**DATE:** March 1, 2012

**MODELS:** All CAIRE Companion Reservoirs (C21, C31, C41)

**ISSUE:** Vaporizing Coil Design Modification

*Figure 1 - - Sections of Vaporizing Coil*

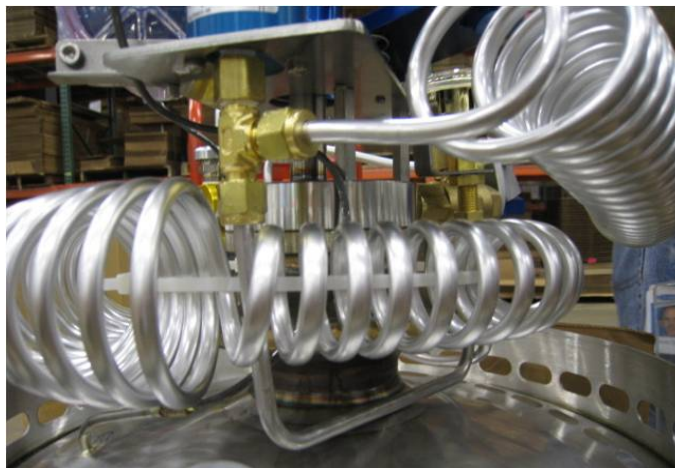
The vaporizing coil will now have two distinct sections. The first section will be tightly wound and have a smaller diameter. Liquid oxygen (LOX) will travel through this more compact section when it first exits the manifold during withdrawal. The diameter of the vaporizing coil will then increase to a less tightly wound section with a larger overall diameter. This change in coil diameter is illustrated in Figure 1 below.

**Figure 2 - - Coil Diameter Design Change**

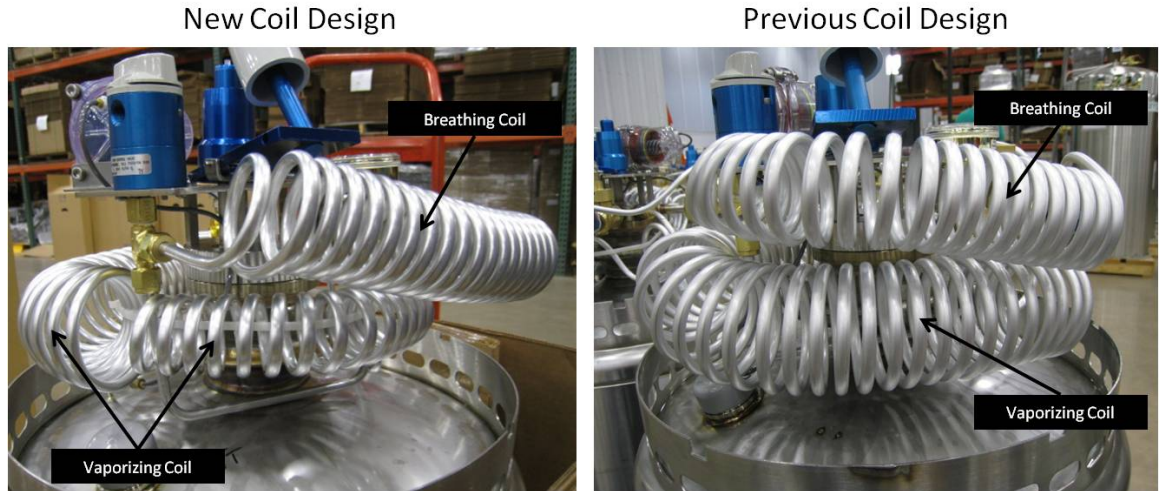
Previously, the entire length of the vaporizing coil was the same diameter throughout the flow path. The addition of this more compact section will bring the warming coils in closer to the manifold and further away from the shroud. This will decrease the amount of frost that can accumulate on the shroud during

normal operation, and thereby reduce water run-off. Figure 2 below illustrates the change in the coil design.

**Figure 3 - - Manifold Outlet Design Change**

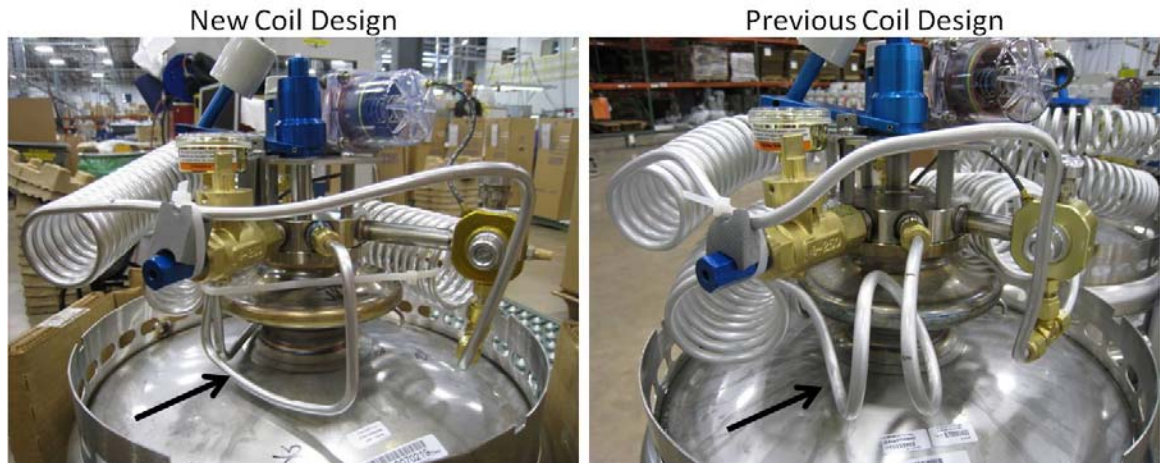
This modification will also change the coil shape after it exits the manifold. Previously, the spiral section of coil began immediately after the connection to the manifold. With the revised design, there will be a straight section of coil leading from the manifold to the smaller diameter spiral section. This too will serve to reduce frost accumulation. It will also keep the control valves ice and frost free, as well as ensure that the vent valve remains functional. Figure 3 below illustrates this design change.
